Architectural Commission Report

- Meeting Date:** Wednesday, August 21, 2013
(Continued from the Architectural Commission meeting on Wednesday, July 17, 2013)
- Subject:** **131 SOUTH MAPLE DRIVE**
Request for approval of a façade remodel and new landscaping to an existing multi-family residential building. The Commission will also consider adoption of a Categorical Exemption, pursuant to the California Environmental Quality Act. (PL1309685)
- Project agent:** Nicole Stubblefield - Omgivning
- Recommendation:** Conduct public hearing to discuss the project details and provide the applicant with an approval.
-

Response to Comments (AC Meeting July 17, 2013)

131 S. Maple Drive

PROPOSED NORTH ELEVATION ①

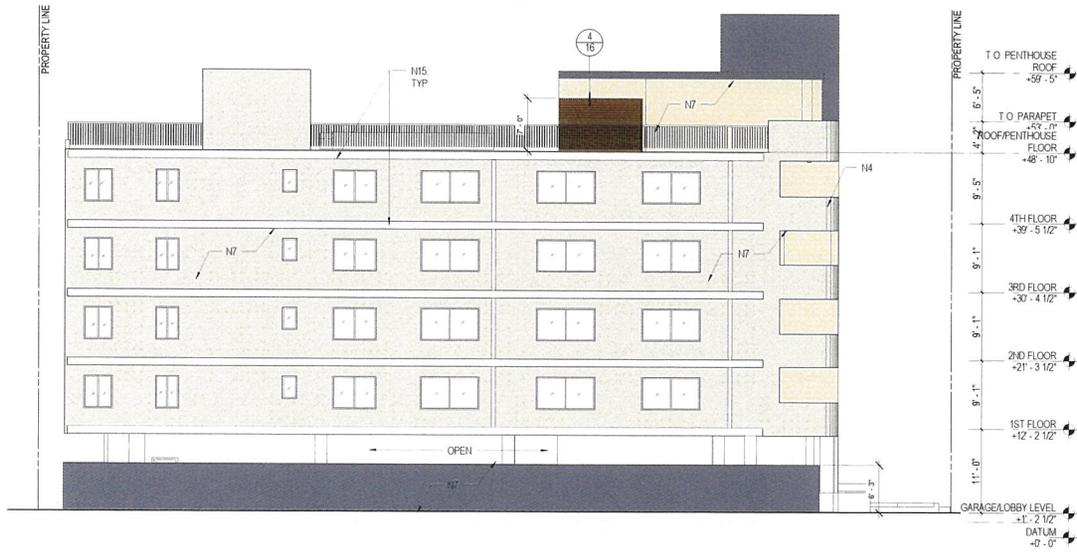
Vertical return to grade of metal clad canopy not permissible.

Stacked stone veneer at front planter does not relate to any element in façade.

Reconsider the driveway gate/screen, it could be rounded so it doesn't visually bisect the (e) rounded balconies above. Additionally the masculine screen seems like an abrupt contrast to the fifties lace block.

This element has been eliminated.

Stacked stone veneer has been changed to exterior cement plaster. Also, we have darkened the color to match the stair tower and help anchor the building.

The wood plank privacy screen/security gate has been pushed back 33'-0" from property line and existing planter wall has been extended into (e) garage. Provides a softer transition between the block and security gate as well as tie the materials together in the façade.

SHEET TITLE
Landscape plan

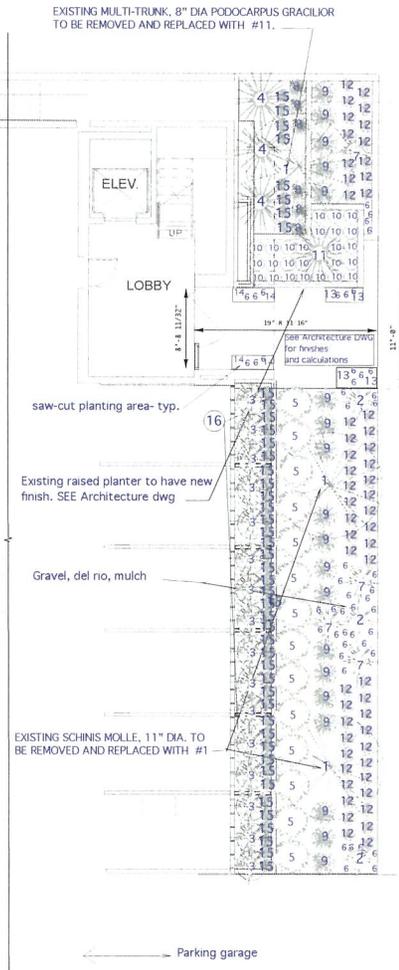
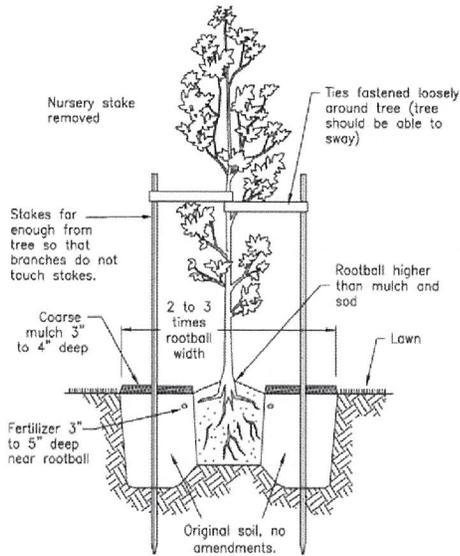
Scale at 1/32"- recommend LA draw at 1/8" need a lot more plants

Size of specimen #7 15 ga. #2 15 ga.

Melaleuca trees are preferred over sycamore, consider changing them to Melaleuca and maintain same type of tree to unite the landscape

Entry, prime space for specimen, flat shrubs. In addition to the myrtle.

Layer of interesting ground cover that will cascade over the high planter.

East facing, specified plants need more light.

Plan scale has been adjusted to 1/8" = 1'-0"

Size of plant material was increased where appropriate.

Melaleuca quinqueneria were added back in. Rhus lancea and Platanus were removed.

Focal plant added #11, w/ appropriate groundcover #10, dudleya were added.

Additional #3 plants were added and groundcover, Acorus and escherveria, to upper planting was added.
